TRANS/WP.29/GRSP/2001/16/Rev.2  
8 November 2002

PROPOSAL FOR DRAFT SUPPLEMENT TO REGULATION No. 44  
(Child restraints)

Transmitted by the Expert from France

Figure 0d

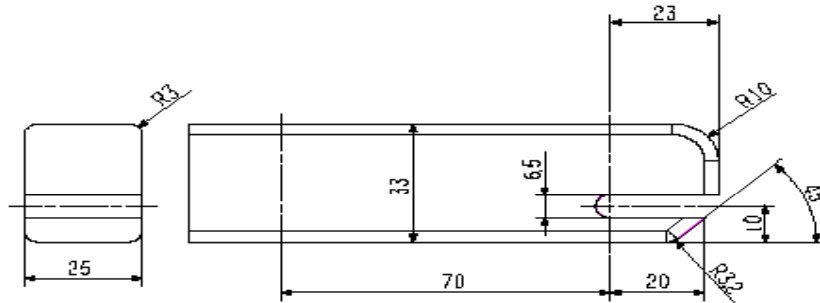
Dimensions for the portion of the ISOFIX child restraint system attachment that engages the ISOFIX anchorage system must not exceed the maximum dimensions given by the envelope in Figure 0d

Figure 0e: ISOFIX Top tether connector (hook type) dimensions

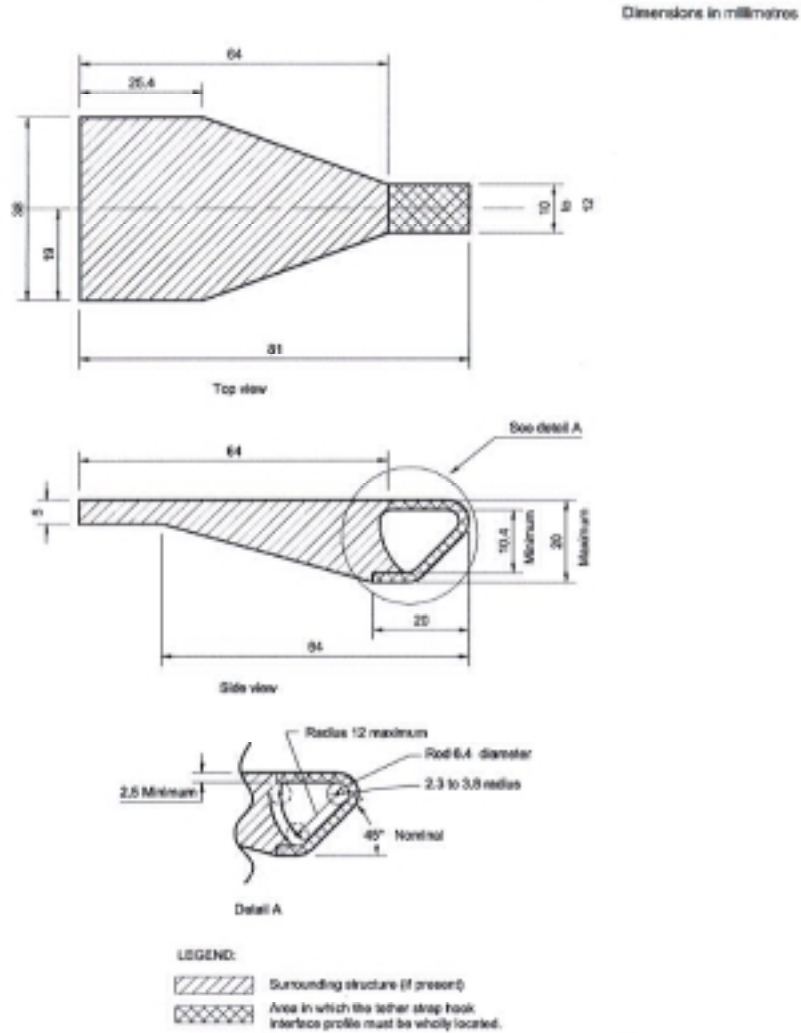
The top tether connector should be ISOFIX top tether hooks as shown in Figure 0e, or similar devices that fit within the envelope given by Figure 0e.

Engagement dimensions for ISOFIX top tether hooks are shown in Figure 0e.

Figure 2

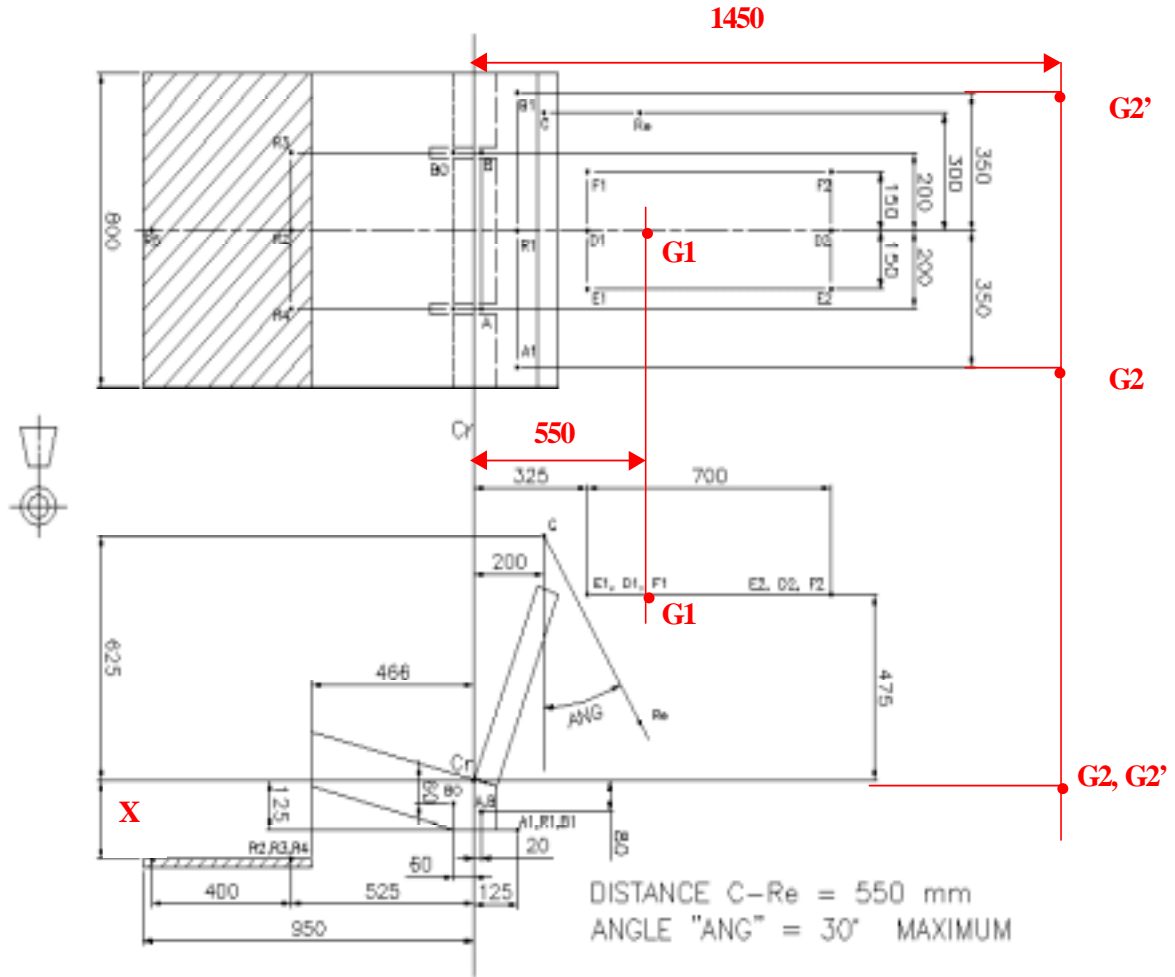
3.3.1. The floor pan of the trolley shall be constructed of a flat sheet of metal of uniform thickness and material , see figure 2 of appendix 3 to this annex.

3.3.1.1. The floor pan shall be rigidly mounted on the trolley. The height of the floor pan relative to the CR-point, dimension X in figure 2, shall be adjusted to meet the requirements of paragraph 7.1.4.1.9.

Figure 2, amend to read

Figure 3

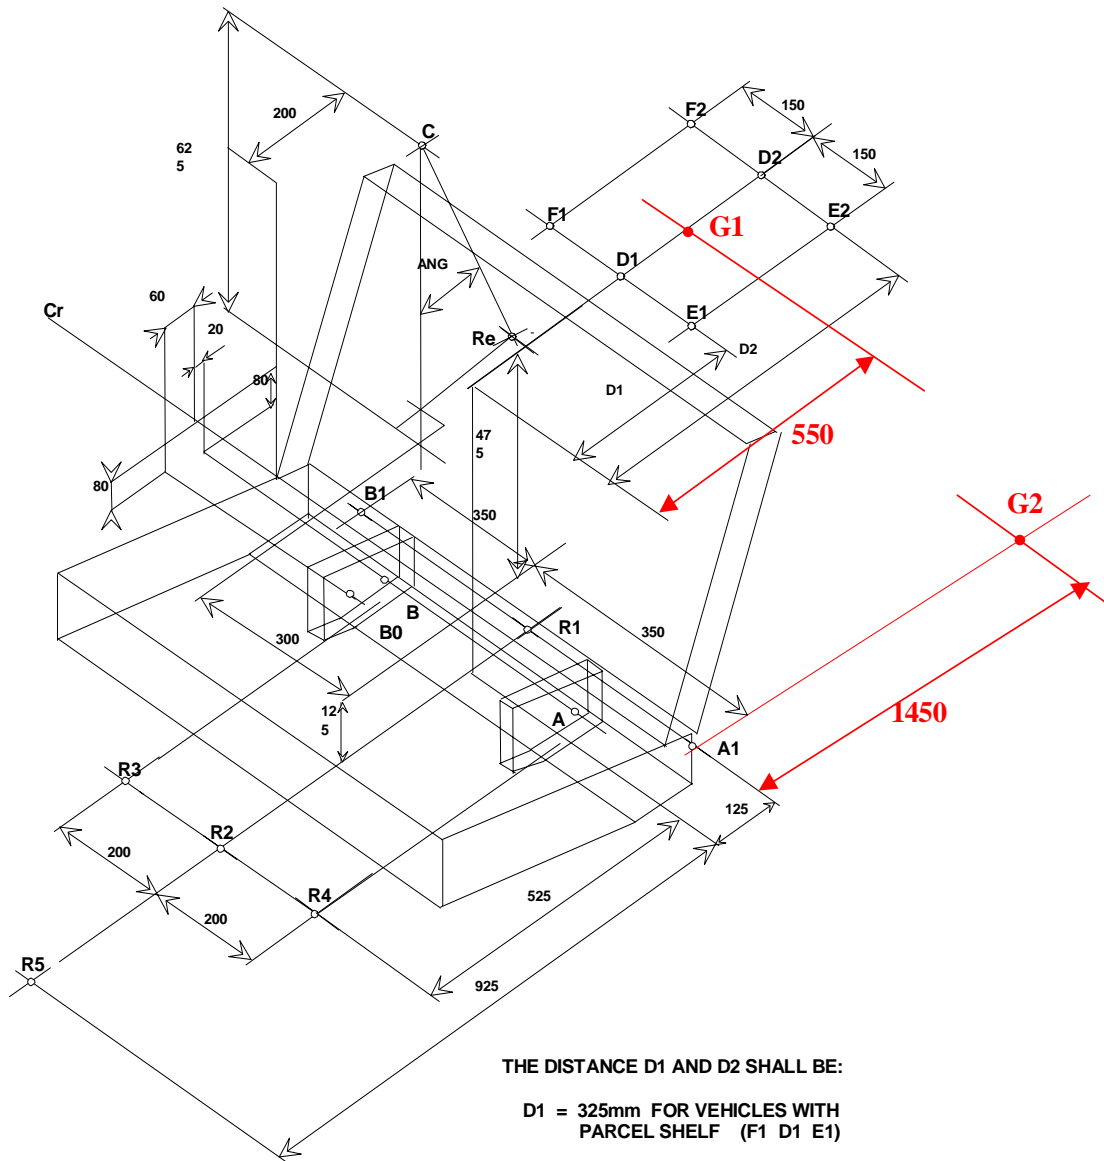
Figure 3, amend to read:

DIMENSIONS REFERRING TO Cr  
ARE TOLERANCED WITH:  $\pm 2$  mm  
EXCEPT FOR DISTANCE FLOOR TO Cr  $\pm 10$ mm

DISTANCE C - Re = 550mm  
ANGLE "ANG" = 30° MAXIMUM

THE DISTANCE D1 AND D2 SHALL BE:

D1 = 325mm FOR VEHICLES WITH  
PARCEL SHELF (F1 D1 E1)

D1 = 1025mm FOR VEHICLES WITH  
FOLDING BACK REAR SEATS  
(ESTATE TYPE) (F2 D2 E2)
